NOTICE OF DECISION

CLASS 3 SITE PLAN REVIEW / CLASS 1 DESIGN REVIEW CASE NO.: SPR-DR23-21

SUMMARY: Proposed 24-unit multiple family residential development with associated common open space and site improvements.

LOCATION: 1341 Waller St SE, Salem OR 97302

Site Plan Review Class 3
Fahman Glaze Apartments
1341 Waller St., Salem, Or

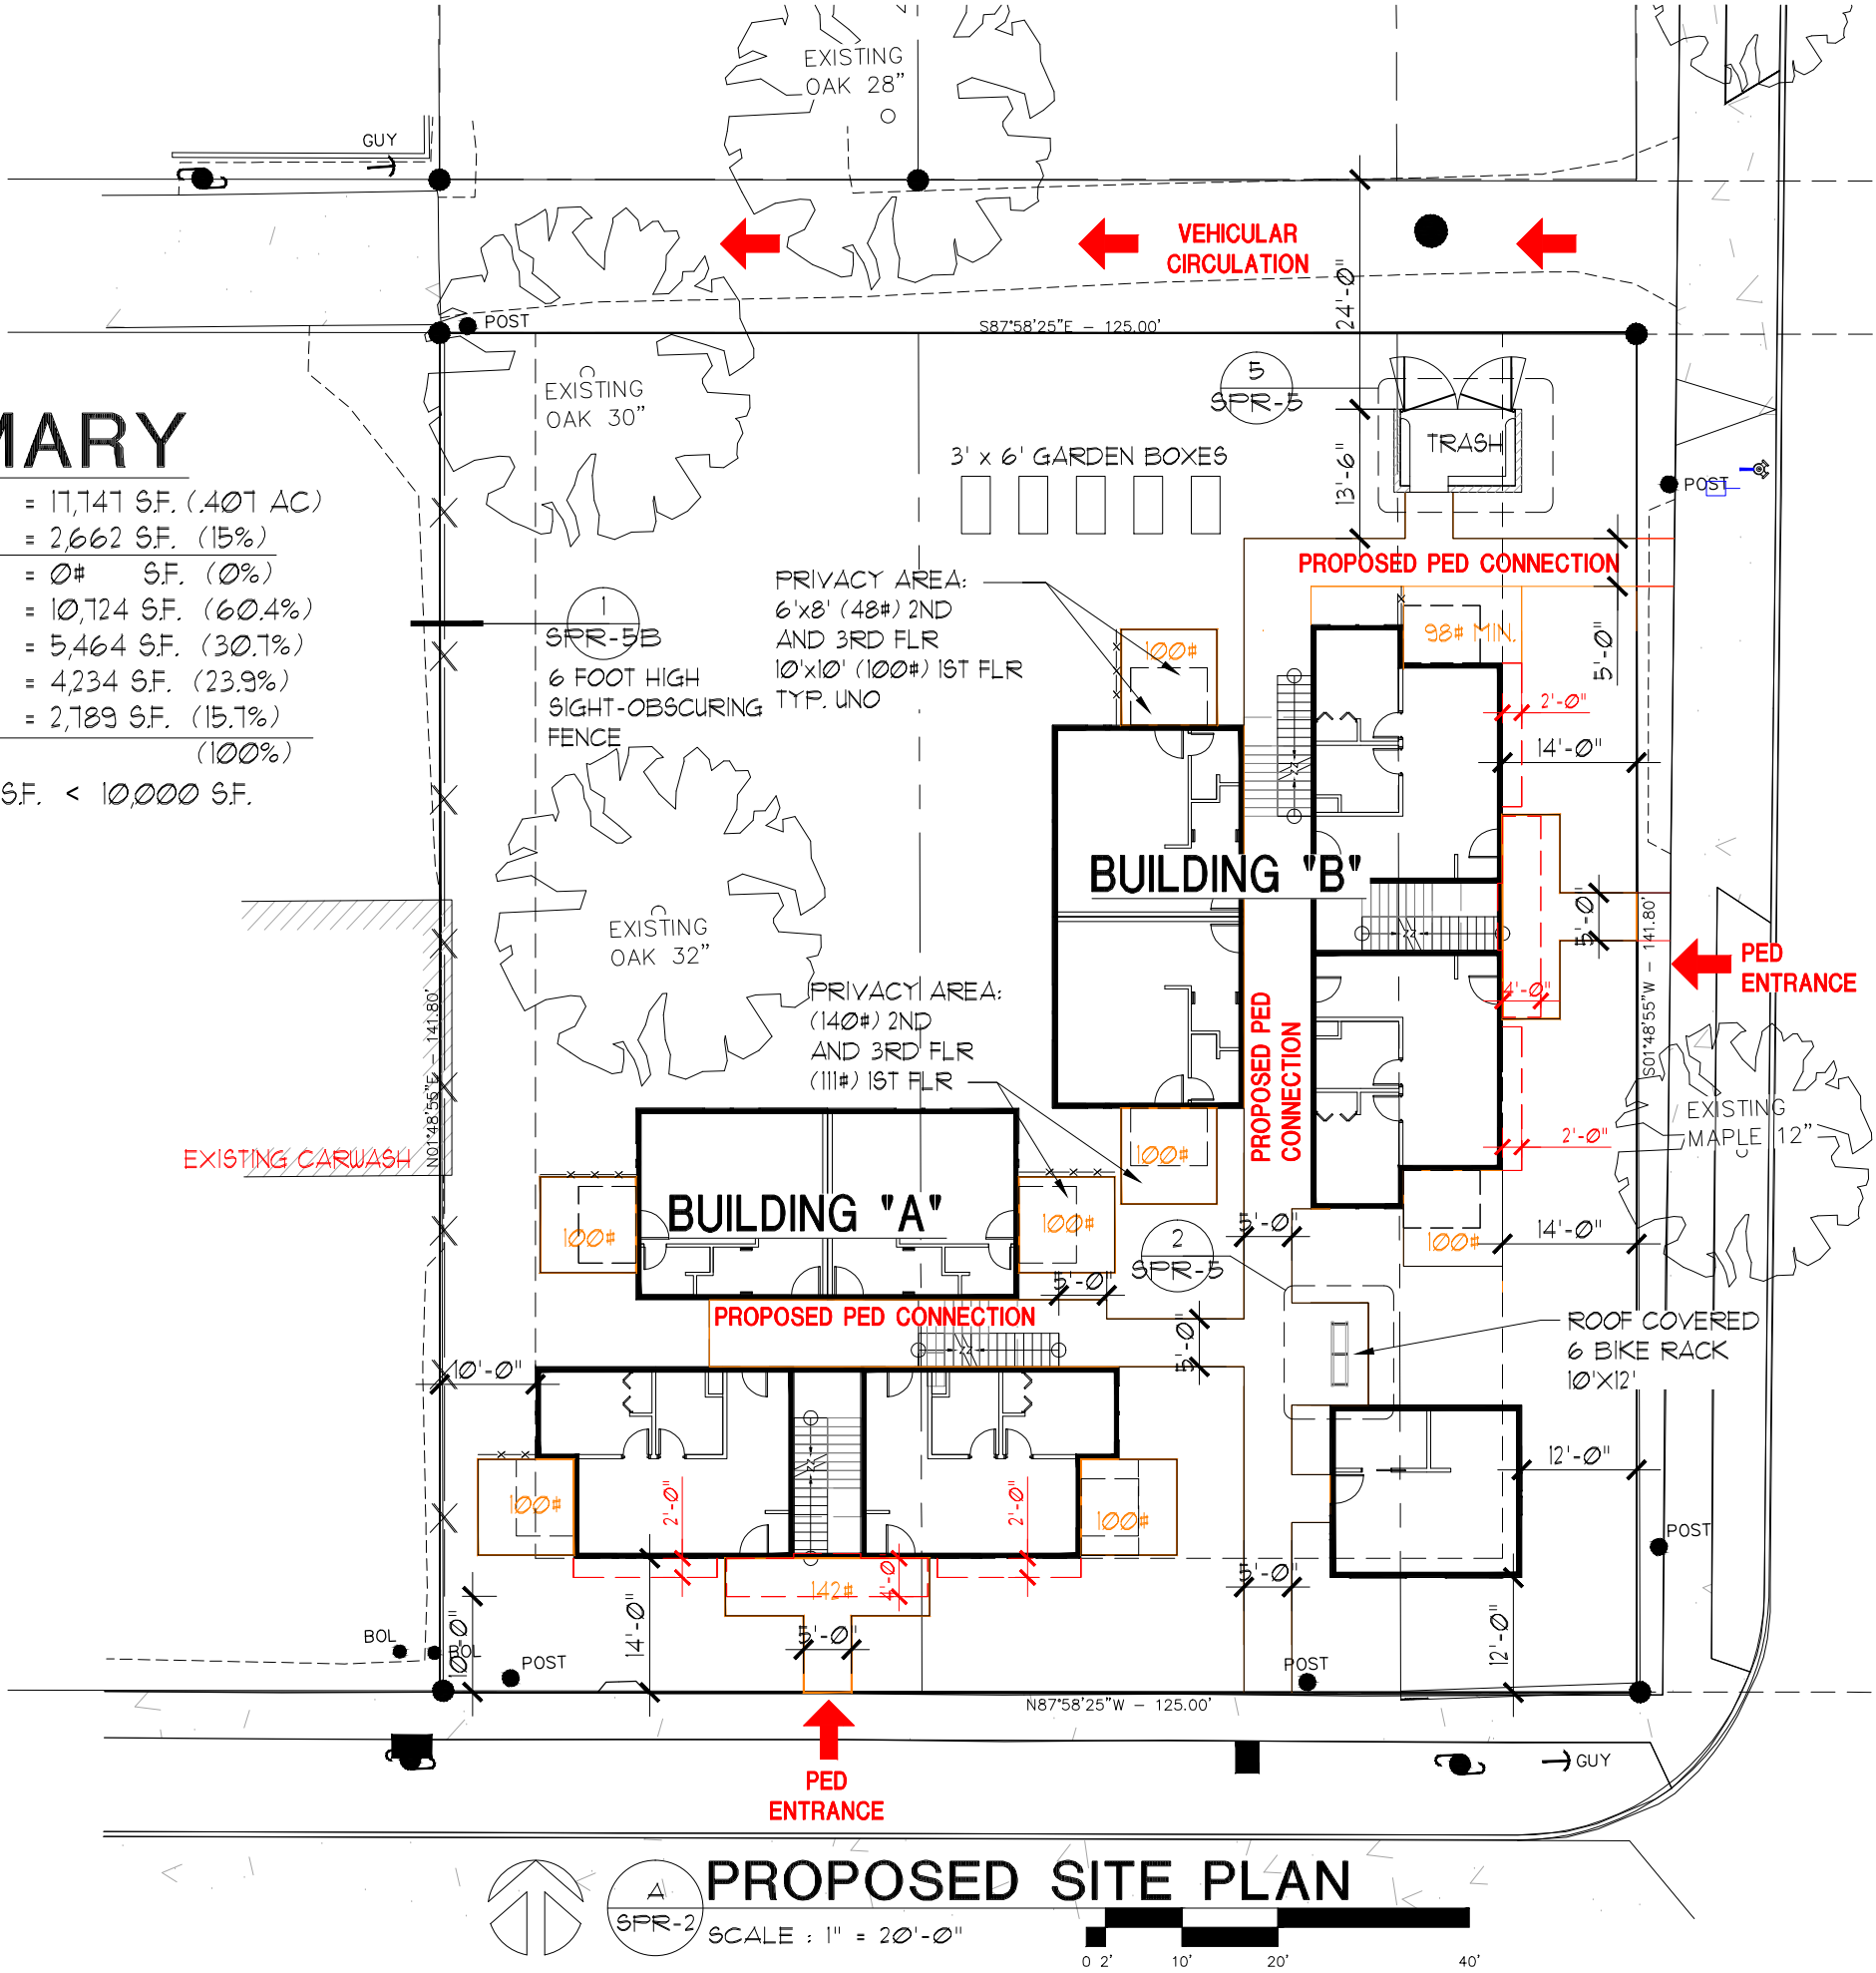
As shown on the site plan, the proposed ground floors of the multiple family buildings are setback 14 feet from the street and at least 10 feet from interior side and interior rear property lines; the upper floors of these buildings are setback 12 feet from the street and at least 10 feet from interior side and interior rear property lines. The proposed multiple family buildings also include eaves, front porches, partially covered ground floor patios, and upper floor balconies/decks which project to varying degrees into required setbacks, but none of these building features project into the required setbacks more than the maximum amounts allowed under SRC 800.035(b), Table 800-2. Based on the setbacks provided, the proposed multiple family buildings conform to the minimum required setbacks of the CO zone.

The proposed development also includes a trash enclosure located in the northeastern portion of the site adjacent to the existing alley. Because the trash enclosure is considered an accessory structure, it is required to be setback a minimum of 12 feet from Lee Street and a minimum of 10 feet from the adjacent alley. As shown on the site plan, the trash enclosure is setback 12 feet from the street in conformance with minimum required setback abutting a street for an accessory structure in the CO zone, but the trash enclosure is setback only eight feet from the alley. Because the proposed trash enclosure does not meet the minimum required 10-foot setback from the alley, the following condition of approval shall apply:

Lot coverage requirements within the CO zone are established under SRC 521.010(c), Table 521-5. Within the CO zone the maximum lot coverage requirement for buildings and accessory structures is 60 percent. As measured on the site plan, approximately 27 percent of the lot is covered by buildings and accessory structures. The percentage of lot coverage proposed does not exceed the maximum 60 percent lot coverage allowed in the CO zone. The proposed development conforms to this standard.

As shown on the site plan, no off-street parking is proposed. The proposed development conforms to this code standard.

Based on the above identified minimum bicycle parking requirement, a minimum of four bike parking spaces are required for the proposed 24-unit multiple family development. As shown on the site plan, the proposed development includes a total six bike parking spaces. The proposed development meets this standard.

As identified on the site plan, the largest common open space area included within the development is located in the northwest portion of the site. The area measures approximately 5,184 square feet in size and has horizontal dimensions of approximately 64 feet by 81 feet. The proposed common open space area exceeds the minimum required size and dimension requirements of Table 702-3, and is not located on land with slopes greater than 25 percent. The proposed development conforms to this design review standard.

- Condition 1:** The proposed trash enclosure serving the development shall be relocated to be setback a minimum 10 feet from the adjacent alley.
- Condition 2:** A minimum 6-foot-tall sight-obscuring fence shall be provided along the north property line of the subject property in conformance with applicable Salem Revised Code standards. The fence is not required between the proposed trash enclosure and the alley.

Condition 2: A minimum 6-foot-tall sight-obscuring fence shall be provided along the north property line of the subject property in conformance with applicable Salem Revised Code standards. The fence is not required between the proposed trash enclosure and the alley.

Attachment C

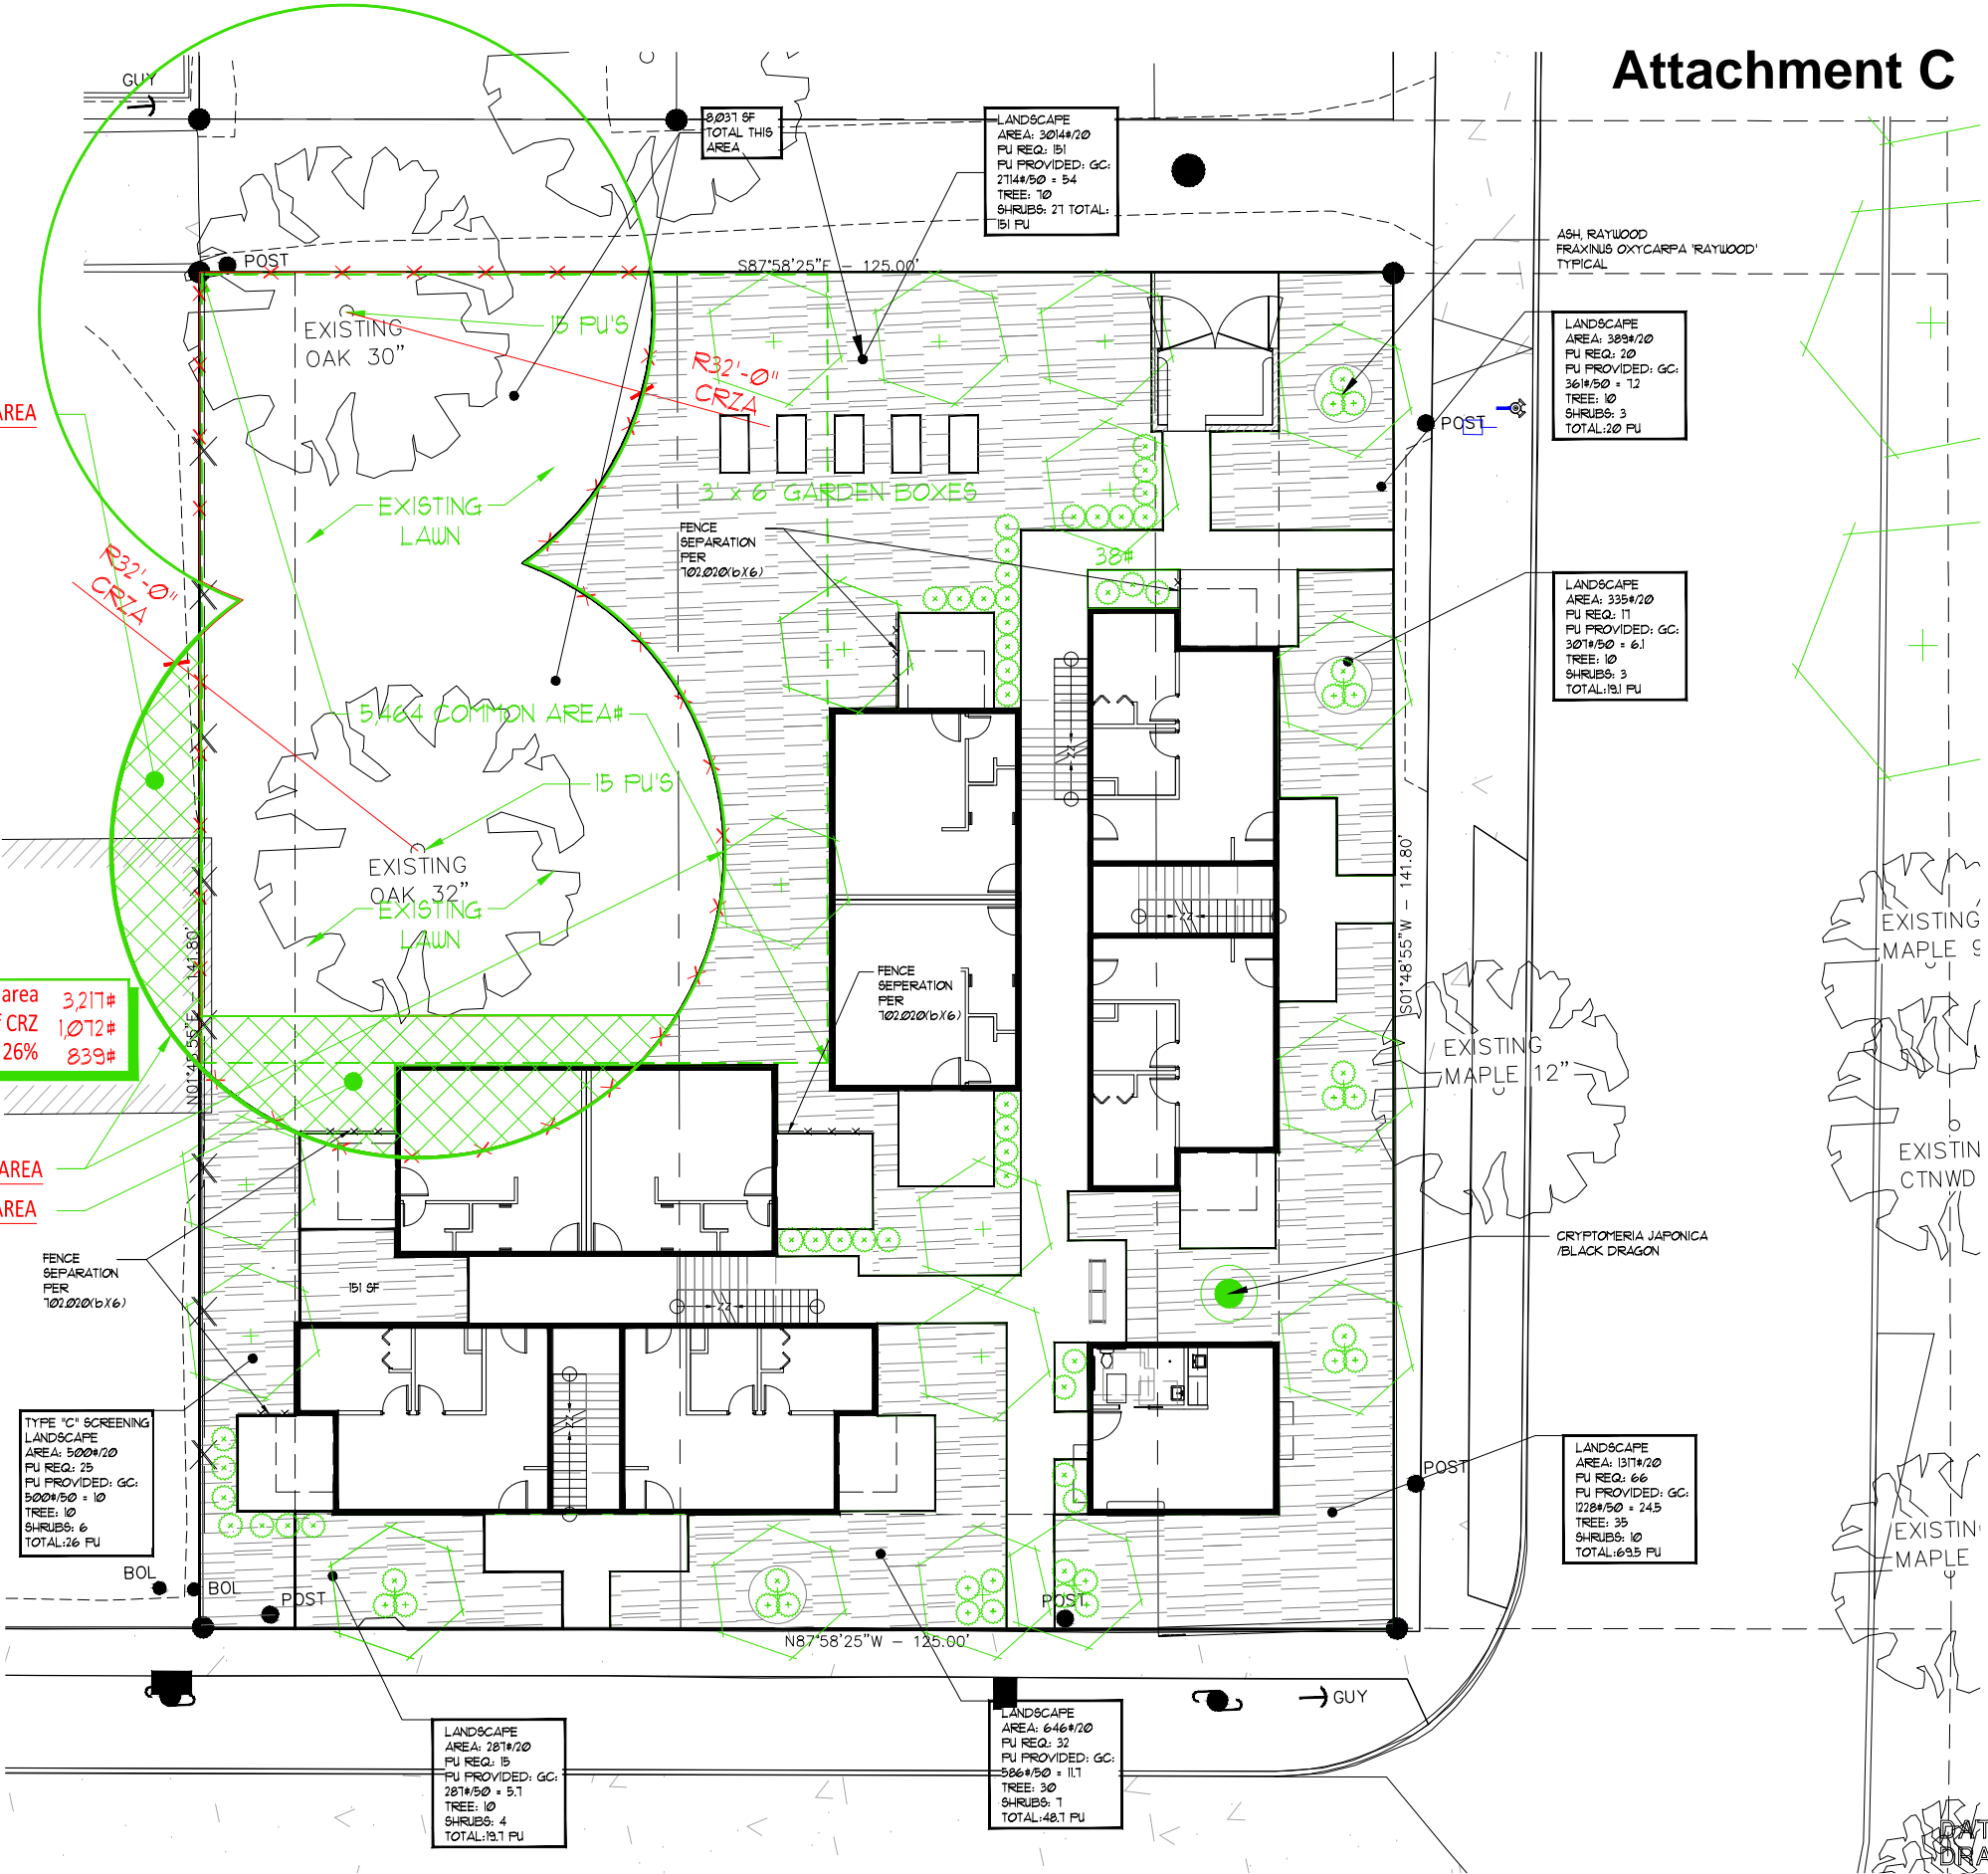
Due to the location of the existing 32-inch oak, the proposed multiple family building on the southern portion of the site will partially encroach into the critical root zone of this tree. As shown on the landscape plan (**Attachment C**), the amount of encroachment equals approximately 26 percent and includes not only the encroachment resulting from the proposed new development, but also existing encroachment from the existing development on the abutting property to the west.

Finding: As shown on the landscape plan, shrubs are proposed to be provided in some areas of the site, but not all of the primary entryways for individual or common entryways include shrubs adjacent to them as required by this standard. In order to ensure that the primary entryways to individual units and combination of units are defined and accentuated with landscaping as required by this design review standard, the following condition of approval shall apply:

Finding: As shown on the landscape plan, shrubs are proposed to be provided around the buildings in some areas, but based on the information provided it's not clear whether the minimum required number of plant units in the form of shrubs is being provided around the buildings. In order to ensure that shrubs are planted around the perimeter of the proposed buildings in conformance with the design review standard, the following condition of approval shall apply:

- Condition 6:** Protective fencing for the 32-inch oak on the property shall be provided that encompasses 74 percent of the critical root zone of the tree as identified in the arborist report included as Attachment I to this decision. The protective fencing shall remain in place until issuance of certificate of occupancy for the development and all recommended protection measures identified in the arborist report shall be followed.

Condition 10: A minimum of two plant units shall be provided adjacent to the primary entryway of each dwelling unit, or combination of dwelling units.

Condition 11: Shrubs shall be distributed around the perimeter of the proposed buildings at a minimum density of one plant unit per 15 linear feet of exterior building wall.

M:/026SITEWK/0111TRASH/02011 TRASH CMU

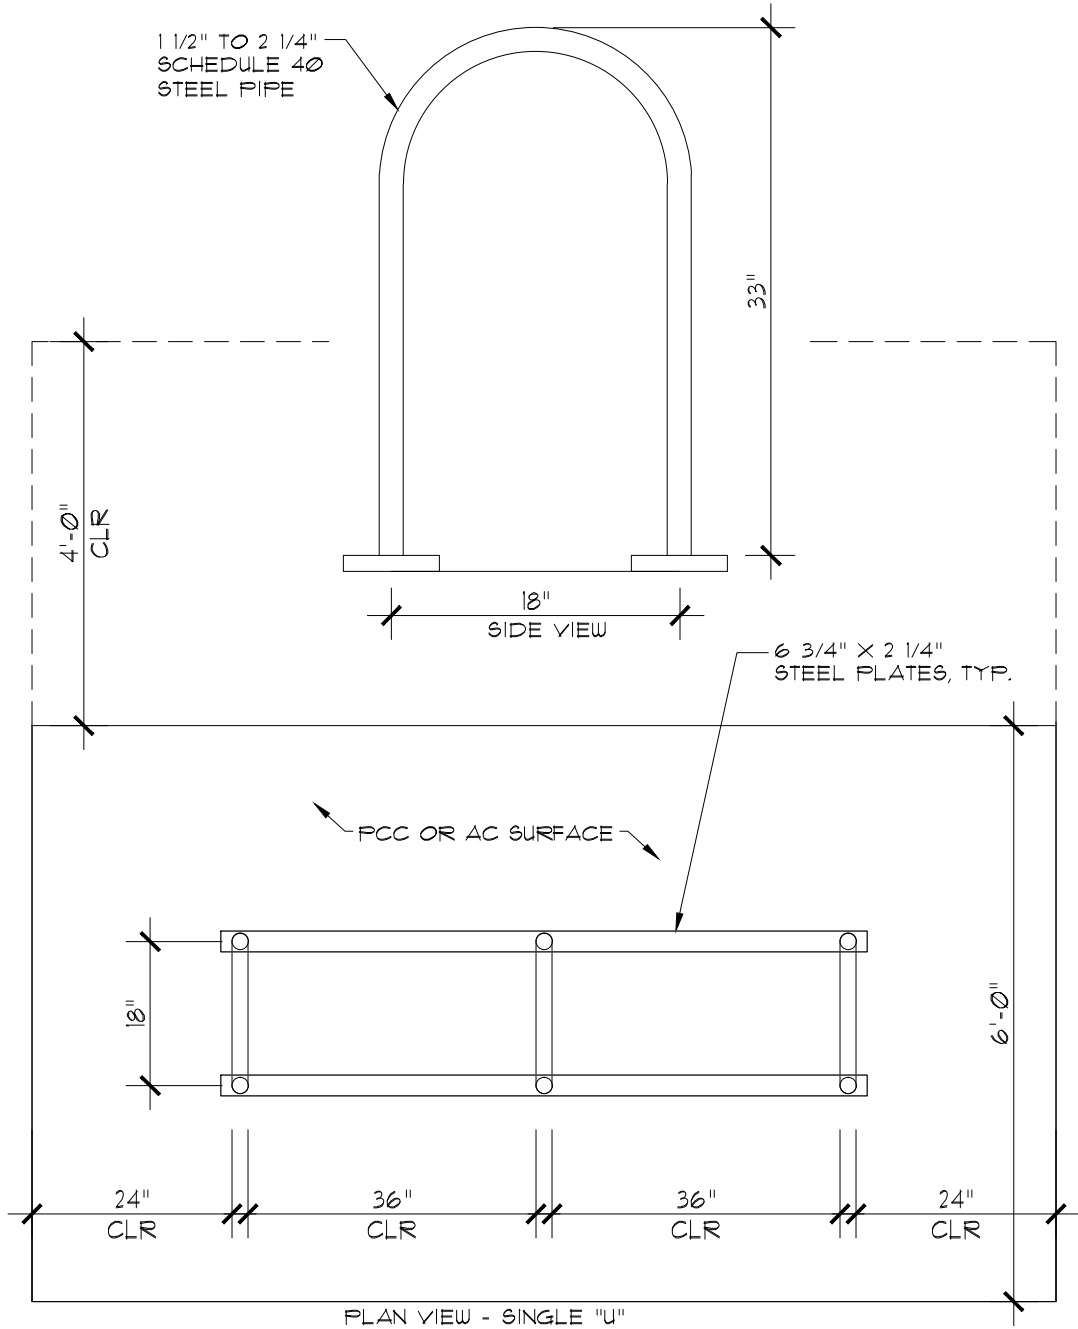
The proposed development includes one trash enclosure/collection area meeting the definition of a solid waste service area under SRC 800.010. As shown on the detail drawing for the proposed trash enclosure (**Attachment H**), the trash collection area is enclosed by a 6-foot 8-inch-tall cmu block wall in conformance with the screening standards of SRC 800.055, but the front opening of the enclosure does not meet the minimum required unobstructed opening width of 12 feet and the dumpster within the enclosure is not separated the minimum required 1.5 feet from the site wall of the enclosure.

- Condition 4:** The trash/recycling area shall conform to the solid waste service area standards of SRC 800.055.
- Condition 5:** In order to allow for servicing by the franchised hauler, the area located between the front opening of the trash enclosure and the alley shall be paved to the existing edge of the paved alley.
